Customer Bulletin

Groomer Drive Direction Knob Falls Off

Universal Groomer Drive (Fairway)

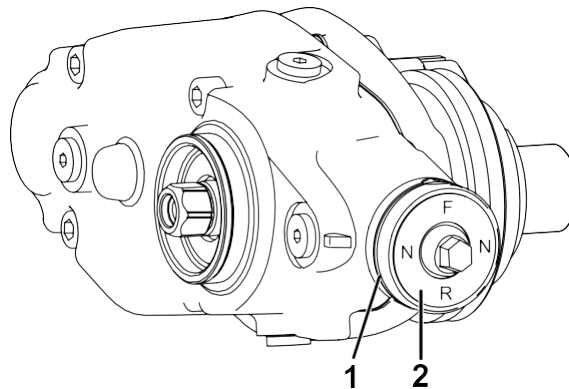
The sun's ultraviolet rays can cause the O-ring on the groomer-direction drive knob to deteriorate, which allows the set pin and knob to fall off of the groomer-drive housing.

1. O-ring

2. Knob

If the O-ring deteriorates, install the Groomer Knob Kit (Part No. 137-0959), which includes a new groomer-drive knob and hex-socket bolt. Refer to your authorized Toro distributor for more information.
